Whitehorse Ratepayers and Residents Association

Presentation to the Suburban Rail Loop East IAC Hearing 21 April 2022

# SRL EAST: NET COMMUNITY BENEFIT OR HARM TO HEALTH & WELLBEING?

Figure DSC12.2 Surface Plan of the SRL station at Box Hill

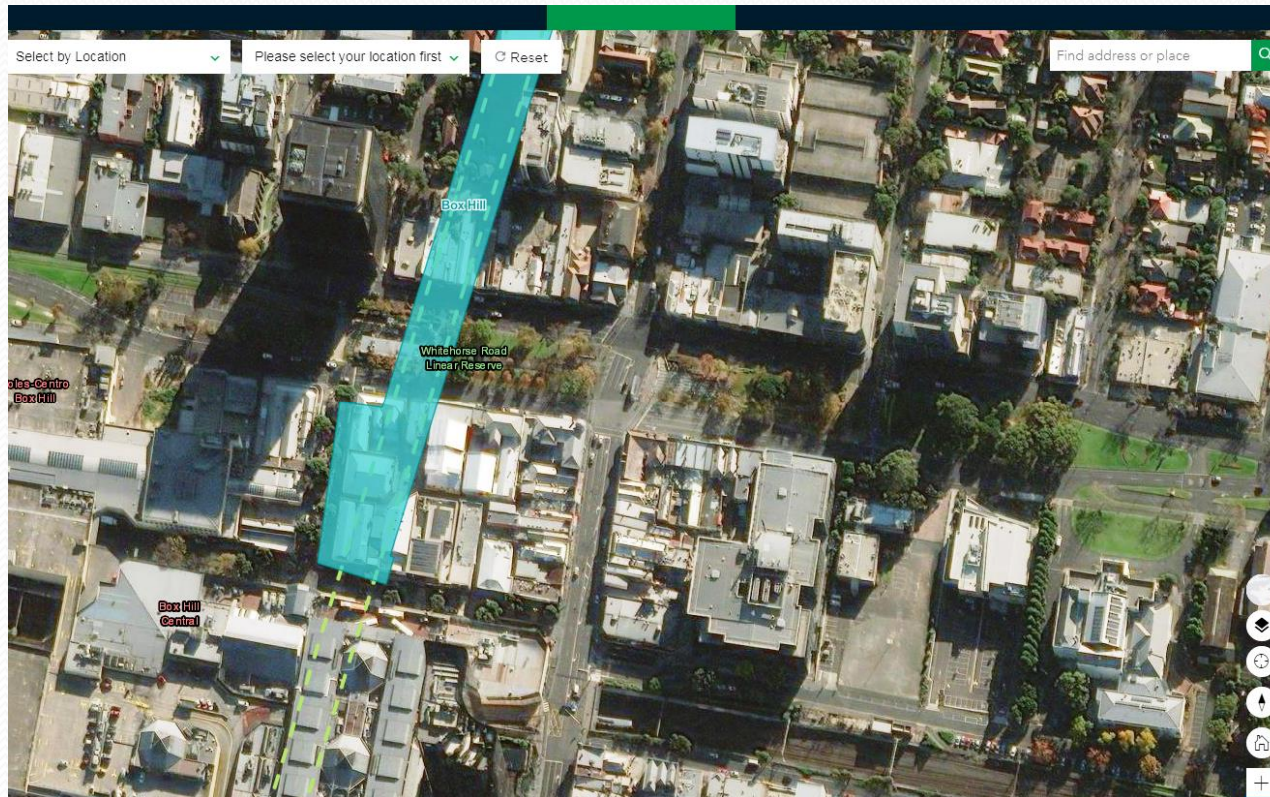
- SRL plans to reduce **Whitehorse Road - a major east-west arterial road** - to two lanes between Clisby and Station Streets and move the westbound lanes further north to encourage active transport. (*\*Contradicted in SRL diagram opposite, showing road realignment from Linsley Street as well.*)
- Need upgrade of existing Box Hill Linear Reserve, **maintaining existing trees** rather than destroying them.
- Important function of existing Linear Reserve re **carbon sequestration (storing)** and **mitigating urban heat island effect** from high density high-rise buildings now and into the future.
- **Visual amenity of existing green Linear Reserve brings welcome relief from high density buildings.**

Leave existing Whitehorse Road alignment alone. Modernise existing Linear Reserve!
